APPENDIX E

Explanation of Bias in the Column Force Data, a Method for Correcting the Bias, and Re-Plotted Data From Both Phases I and II that is Corrected for the Bias

18 July 2000
B-H200-17005-ASI

Subject: Dual Elevator PCA Jam Ground Test - Egyptair 767-300ER SU-GAP, Accident Off Nantucket, Massachusetts – 31 October, 1999

CALC	B. Cook	17Jul00	REVISED	DATE	First Officer's Column Force Biases During Test 10-18	767-400ER VQ001
CHECK						Figure 7
APPD.						
APPD.					BOEING	PAGE 14 of 16

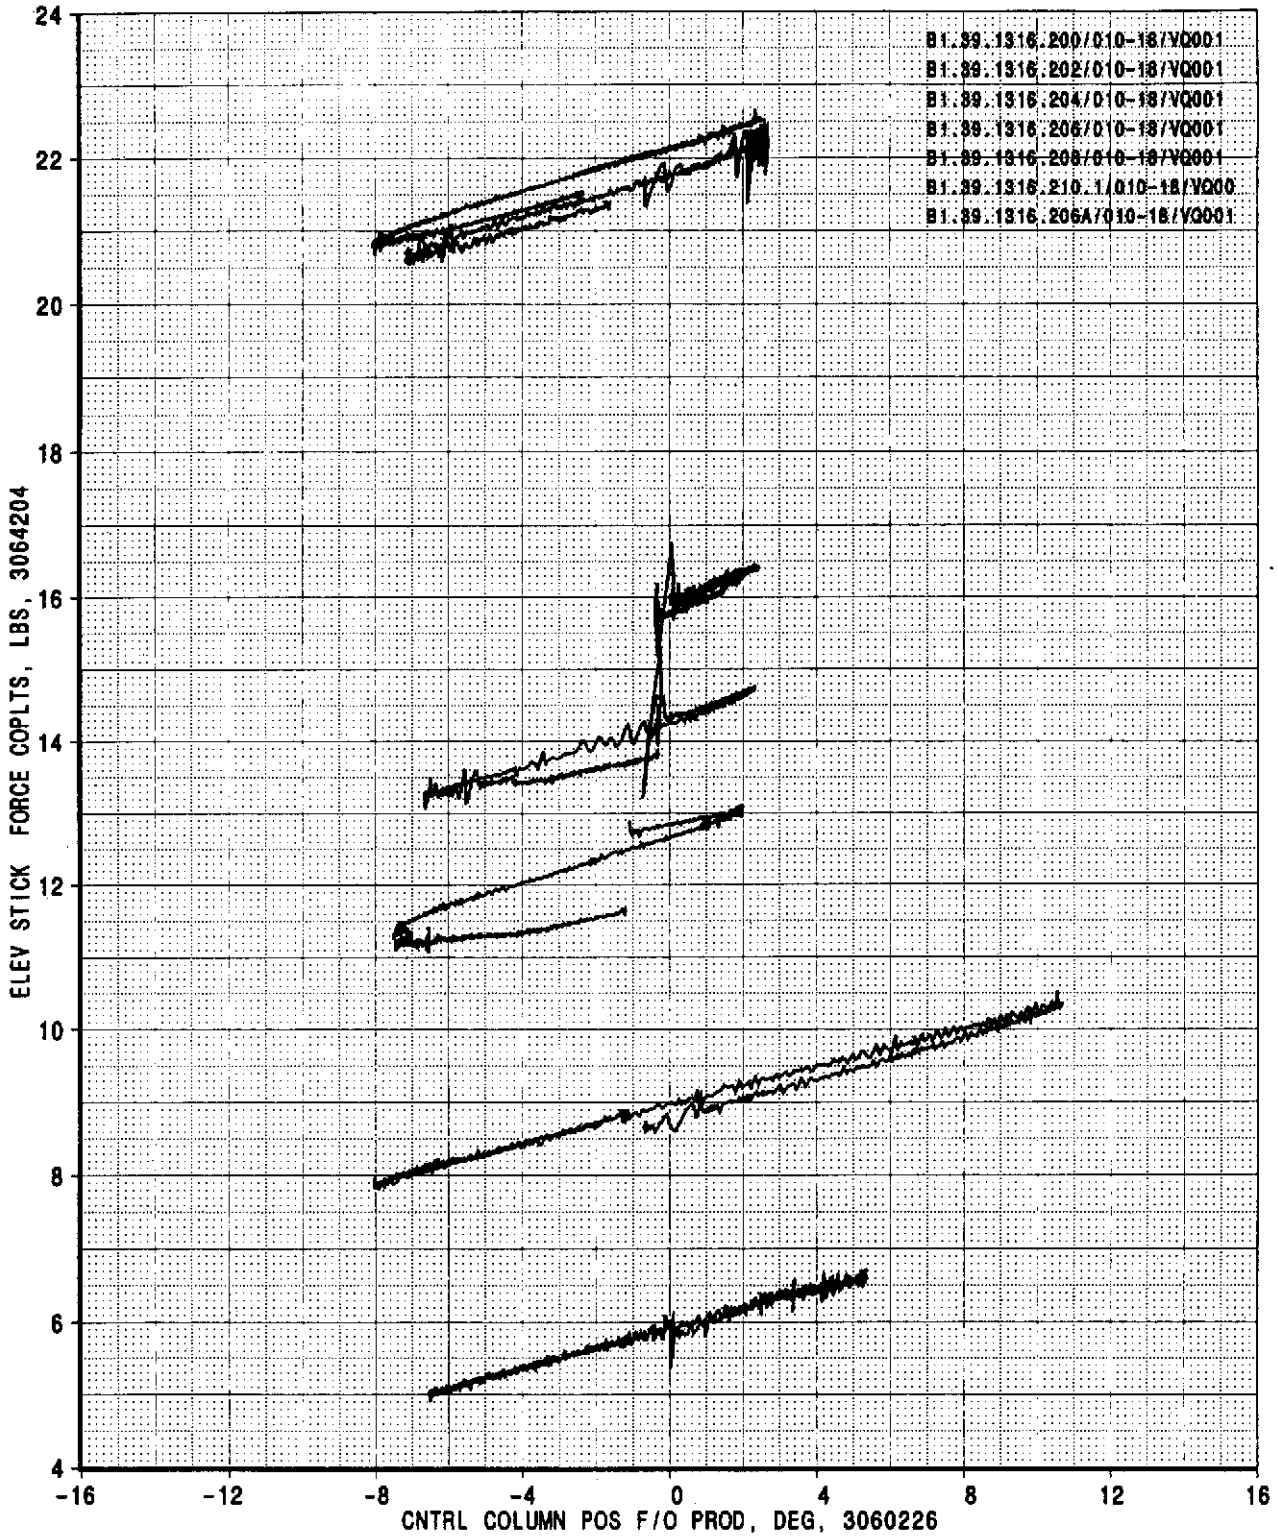
The captain's column force biases during test 010-18 are shown in figure 6. The First Officer's column force biases during test 010-18 are shown in figure 7. These plots were generated using the same methods described above for figures 4 and 5.

For figure 7, the column force instrumentation bias on the first officer's column during test 010-18 varied from 6 lbs to 22 lbs. This is significantly more shift in the bias than that observed during any other test. Test 010-18 was conducted with 3 main test configurations: (1) single input jams, (2) single input jam plus a single disconnect, and (3) dual input jams. Switching between test configurations during test 010-18 required significant amounts of time because elevator PCAs had to be removed and replaced to produce an input jam. A review of the test conditions completed in each of these three test configurations shows that the column force bias values didn't shift more than a few pounds for the test conditions within a single configuration. The major shifts occurred between main test configurations when large temperature shifts occurred while the airplane configuration was changed.

CALC	B.Richardson	17Jul00	REVISED	DATE	Ground Test/Simulation Proof of Match Base Feel Sweep with Biases Removed	767-400ER VQ001
CHECK						Figure 8
APPD.						
APPD.					BOEING	PAGE 15 of 19

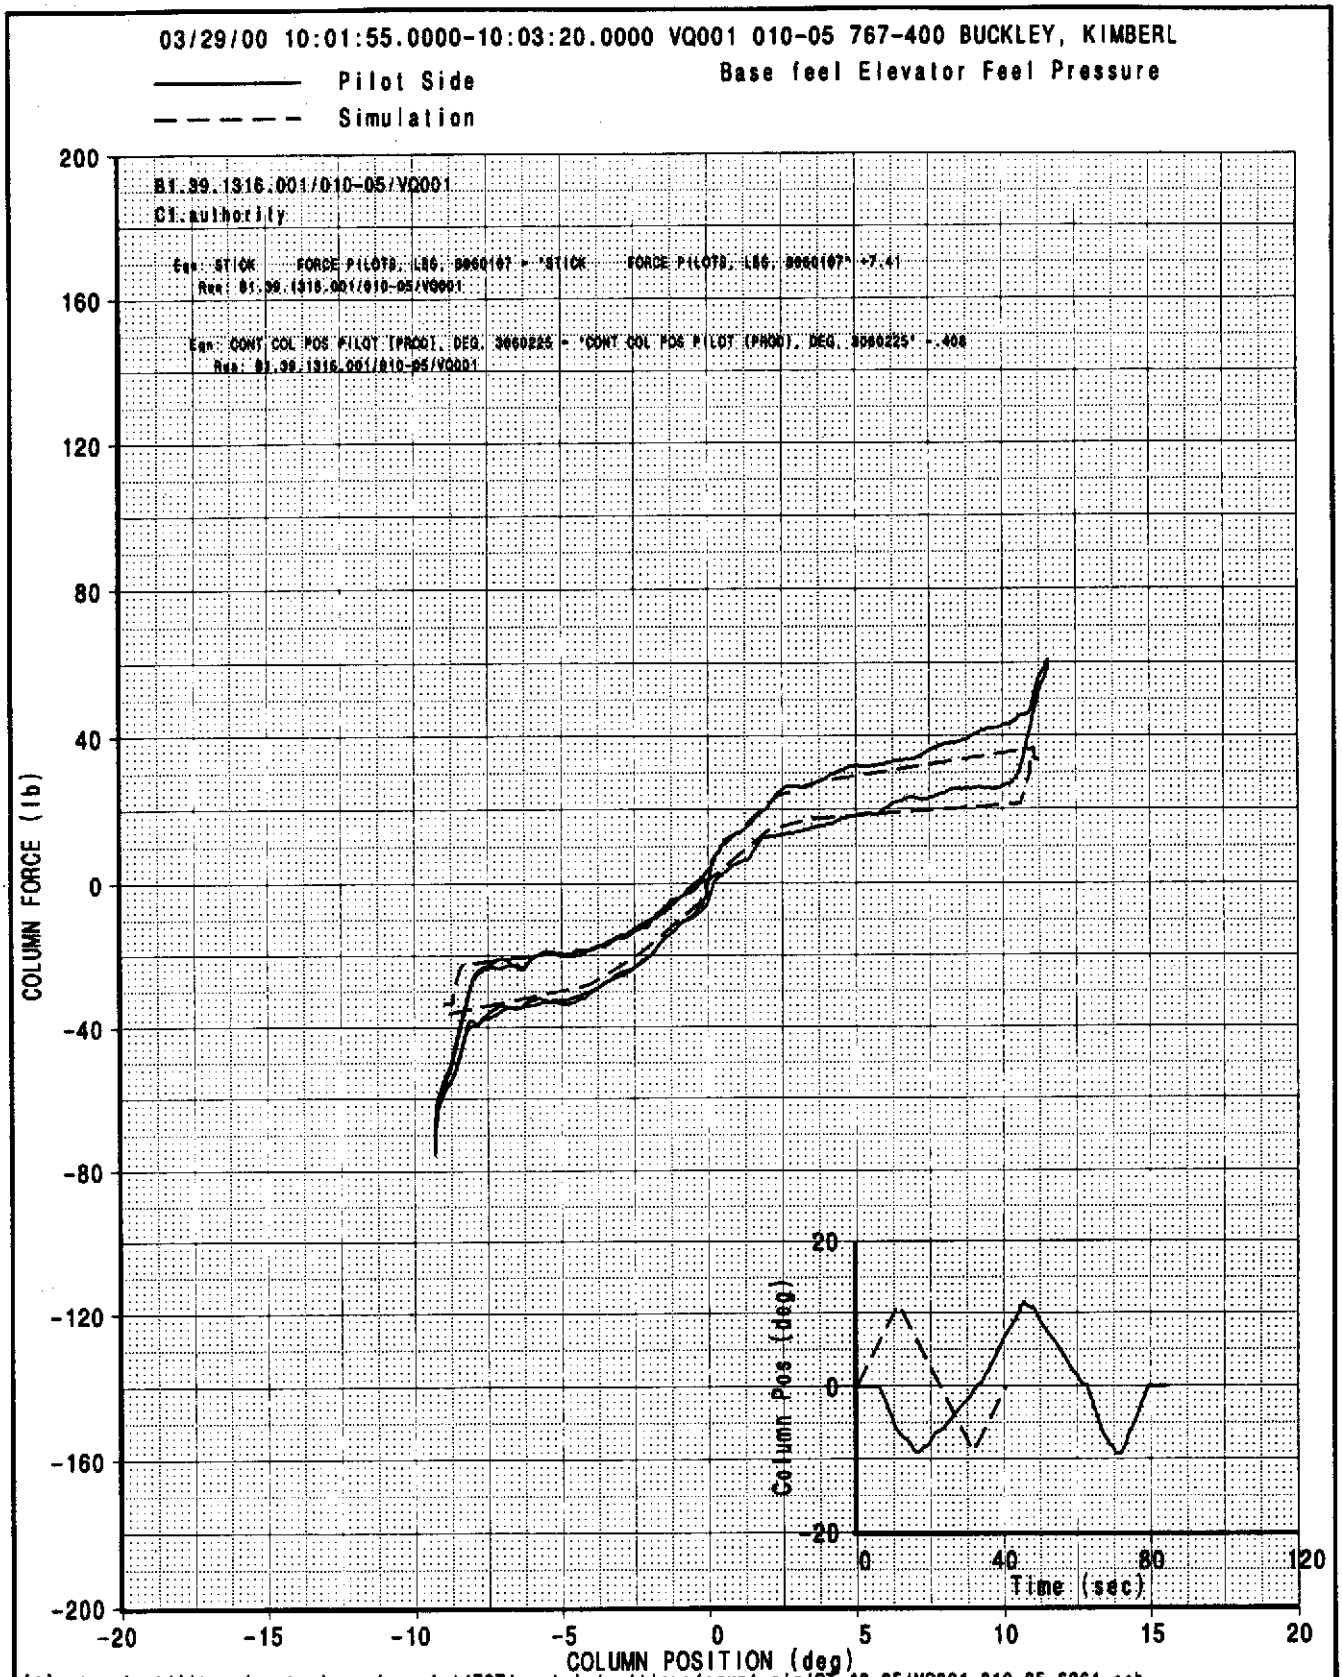
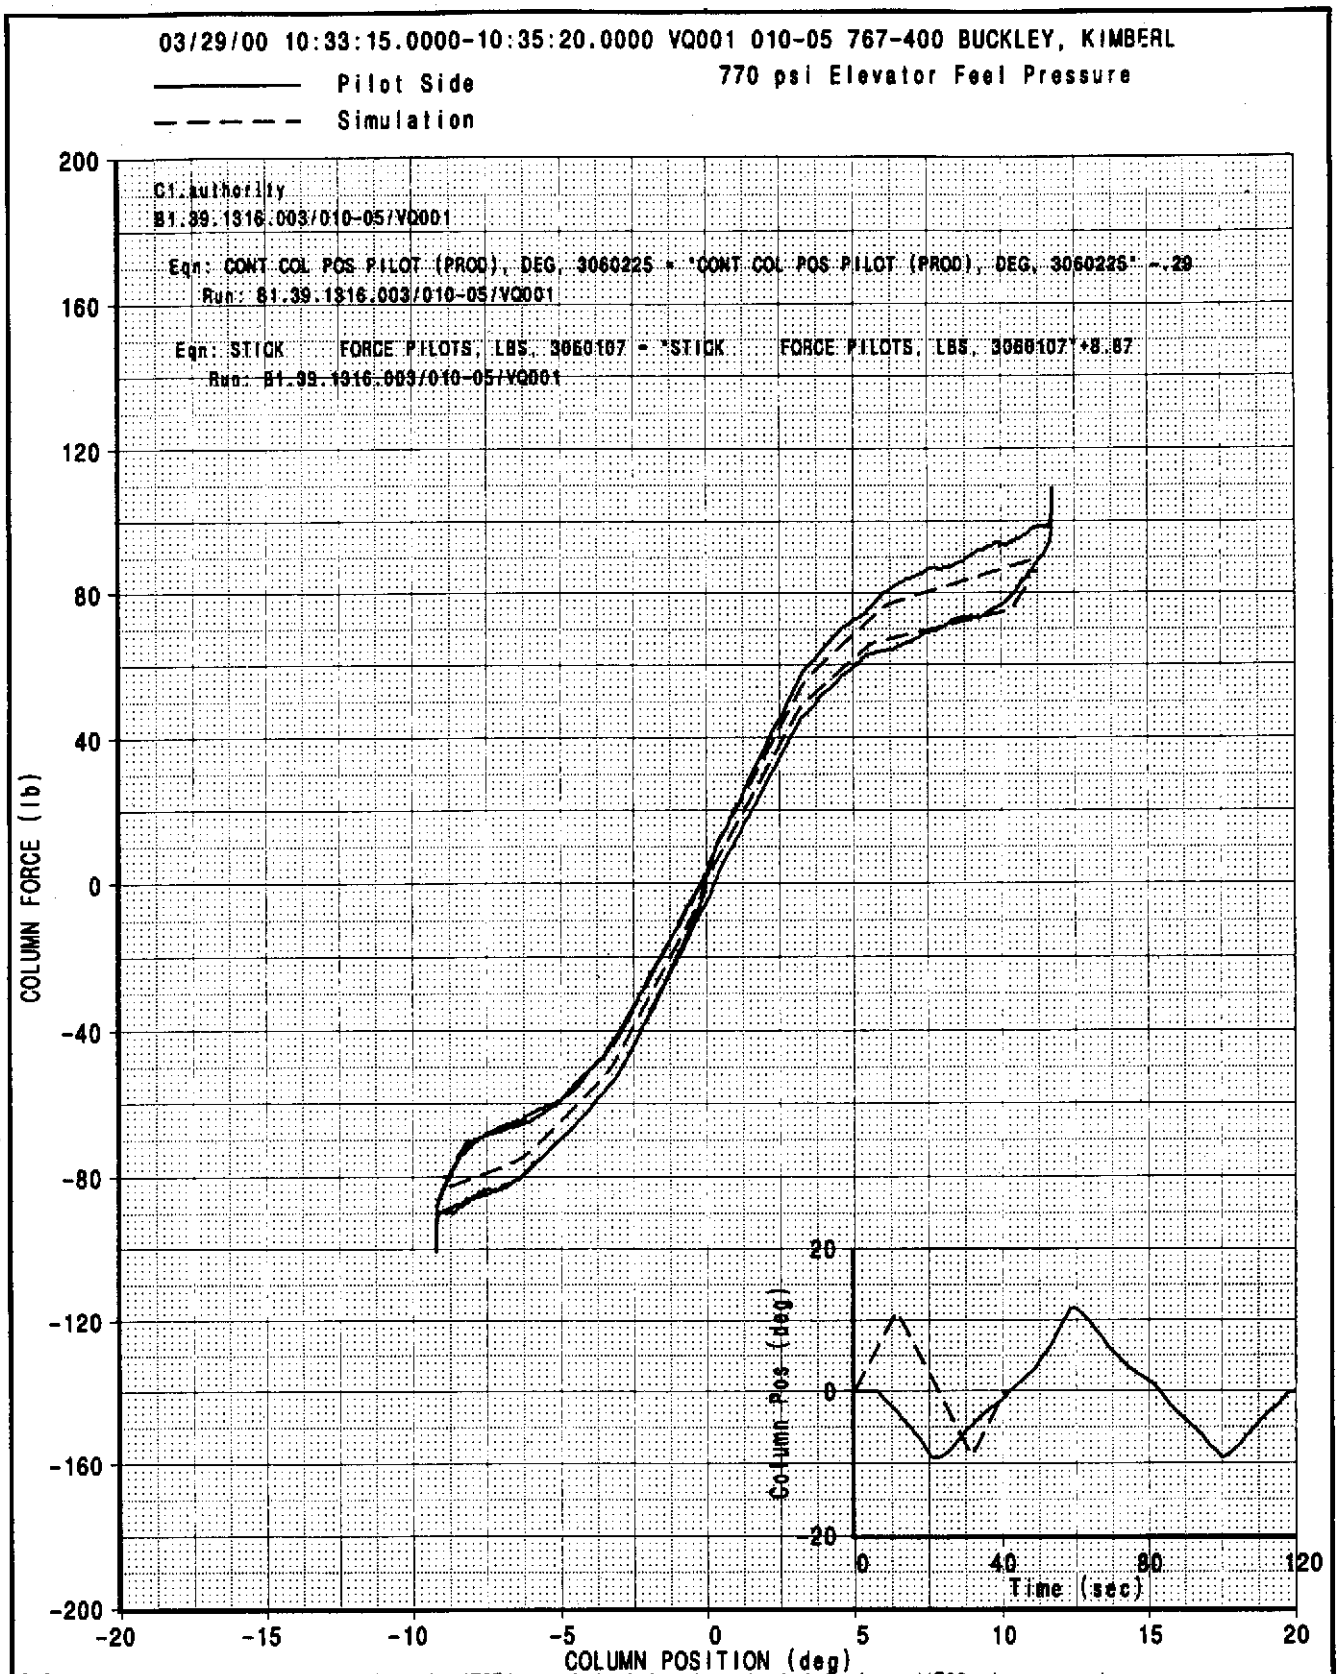
Figure 8 shows a plot of column force versus column position during a column sweep on VQ001 at base feel pressure. Figure 9 shows a plot of column force versus column position during a column sweep on VQ001 when the feel pressure was set to 770 psi. In both figures 8 and 9, the VQ001 test data matched well with the predictions once the column force instrumentation biases were removed. This demonstrates that the column force test data gathered from VQ001 can be easily corrected by removing the instrumentation biases and that the forces measured by the instrumentation once this is done is accurate.

CALC	Brian Cook	21Jul00	REVISED	DATE	Figure 0: Column Force Biases Versus Time 767 PCA Elevator Disconnect Testing VQ001 Test 010-05 on March 29, 2000	767-400ER VQ001
CHECK						BE326-C00-029 Rev A
APPD.						
APPD.					BOEING	PAGE Figure 0

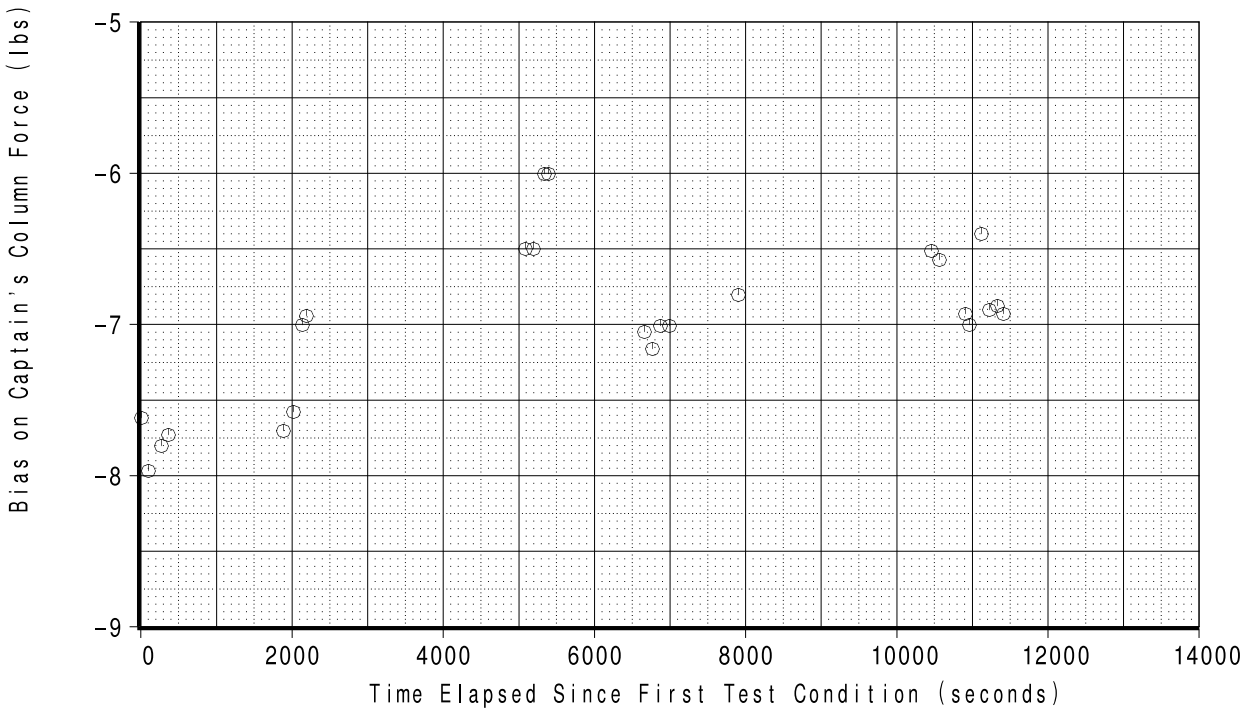
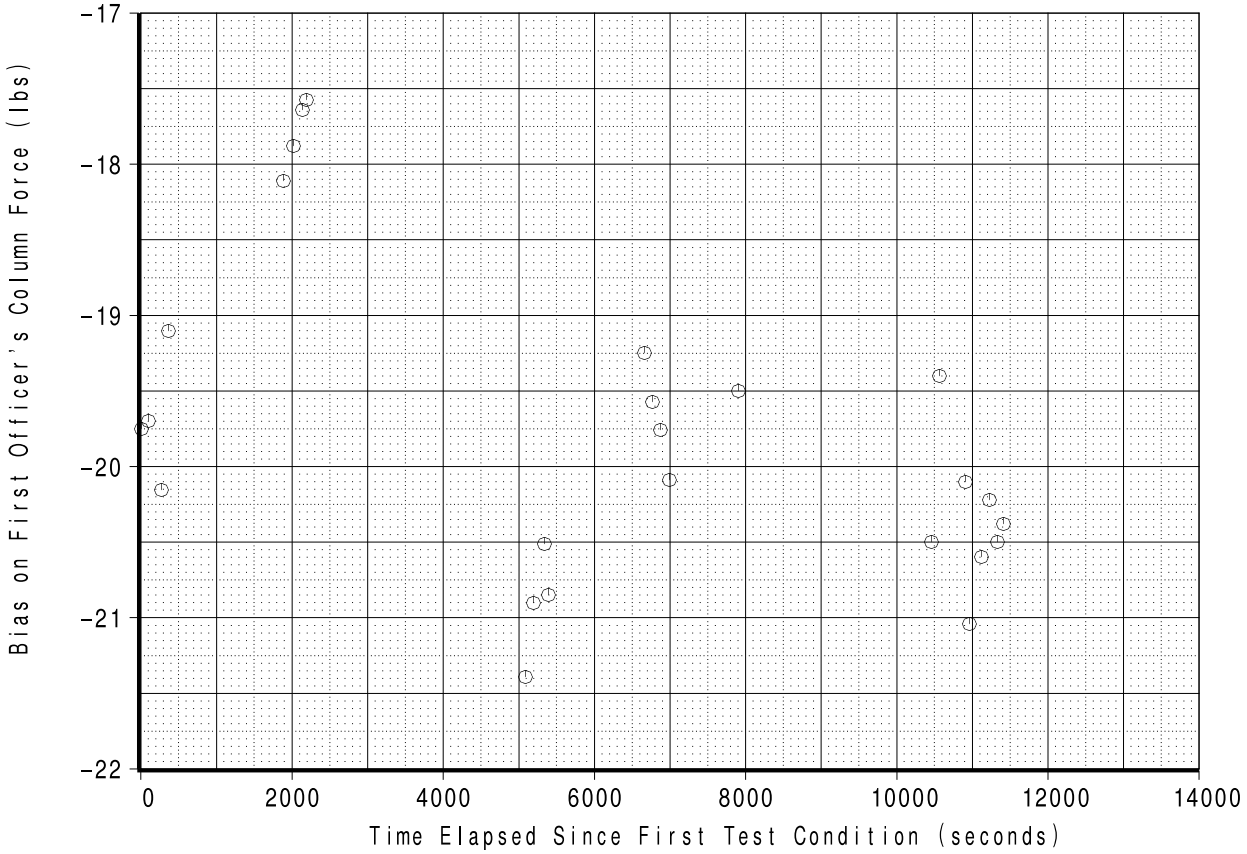
Figure 0 was created to show how the column force instrumentation biases shifted during the test 010-05. Figure 0 plots the column force biases from the table above as a function of the time. From figure 0, it can be seen that the bias on the captain's column force ranged from –6.00 to –7.97 lbs and the bias on the first officer's column force ranged from –21.39 to –17.57 lbs. Within each grouping of test conditions, the biases generally shifted less than 1 lb. The more substantial shifts in biases occurred during the large time intervals between the groups of conditions when larger temperature shifts would be expected to occur.

CALC	Brian Cook	21Jul00	REVISED	DATE	Figure 48.1 Column Force Biases Vs. Time 767 PCA Elevator Jam Testing VQ001 Test 010-18 on April 20, 2000	767-400ER VQ001
CHECK						BE326-C00-029 Rev A
APPD.						
APPD.					BOEING	PAGE Figure 48.1

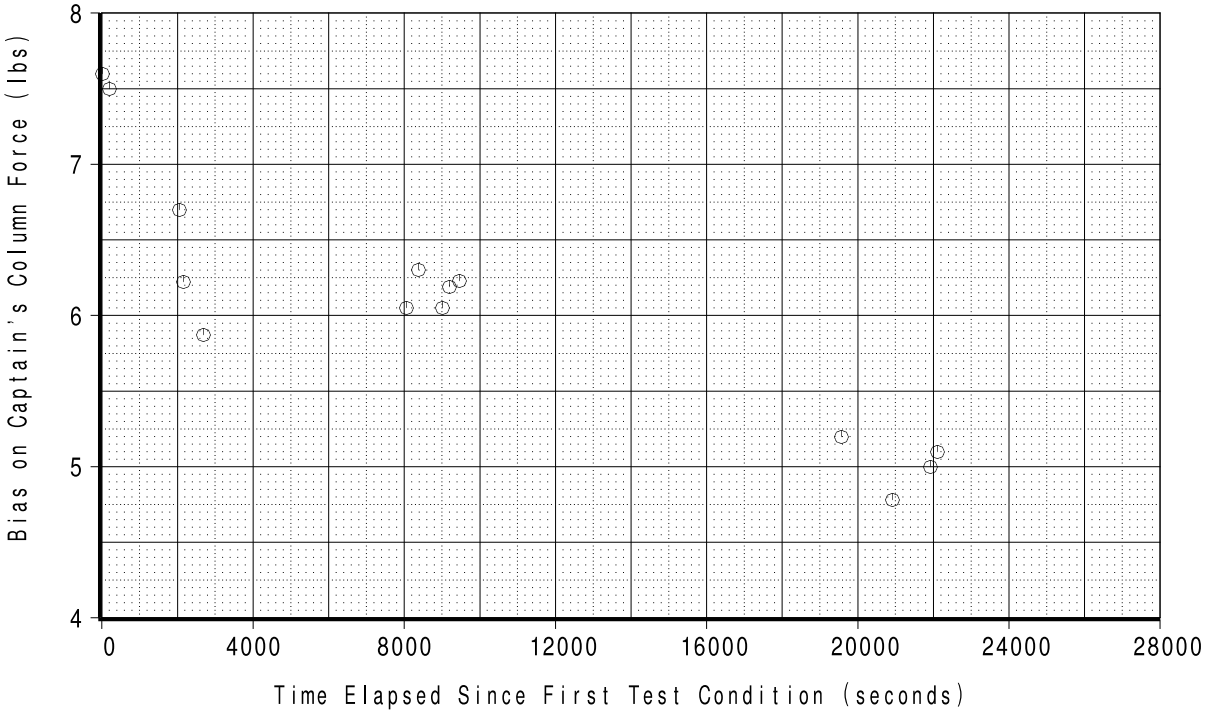
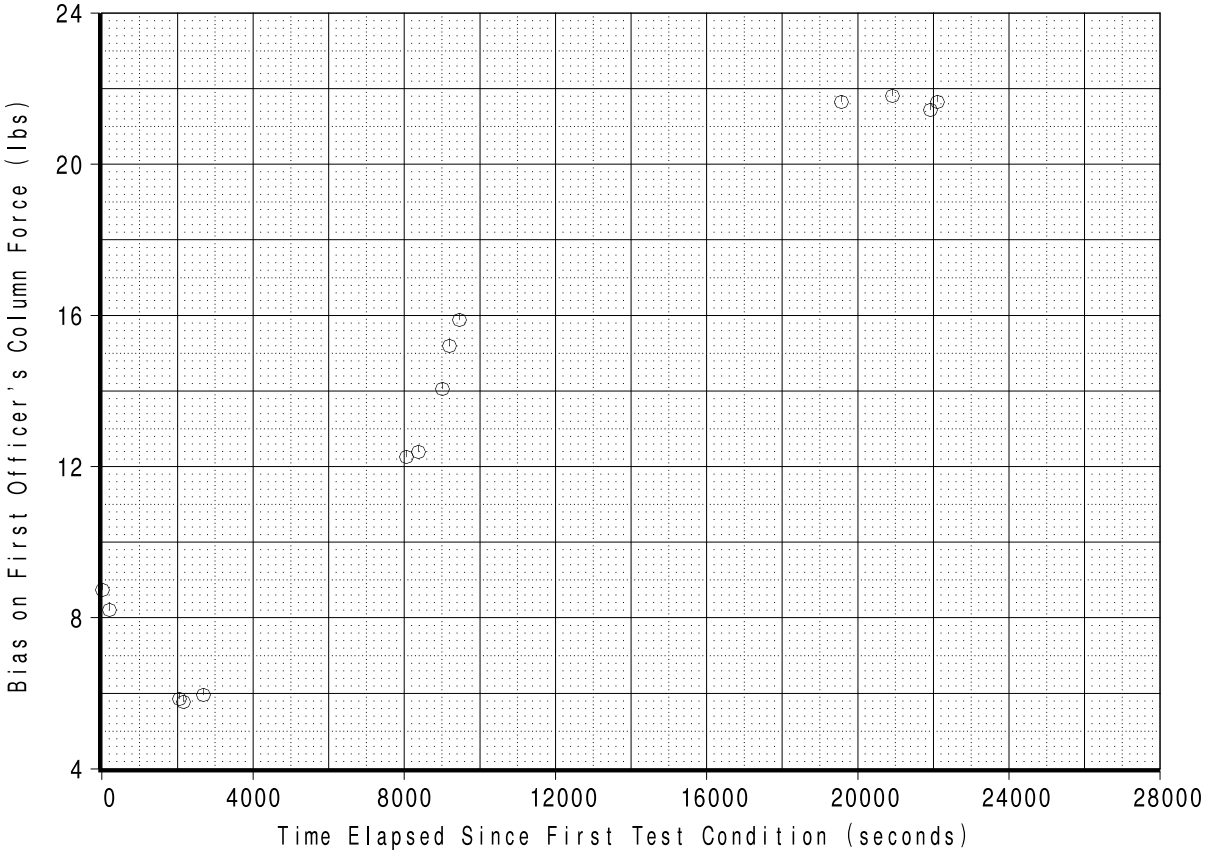
Figure 48.1 was created to show how the column force instrumentation biases shifted during the test 010-18. Figure 48.1 plots the column force biases from the table above as a function of the time. From figure 48.1, it can be seen that the bias on the captain's column force ranged from 4.78 to 7.60 lbs and the bias on the first officer's column force ranged from 5.77 to 21.80 lbs. Within each grouping of test conditions, the biases generally shifted less than a few pounds. The more substantial shifts in biases occurred during the large time intervals between the groups of conditions when larger temperature shifts would be expected to occur.
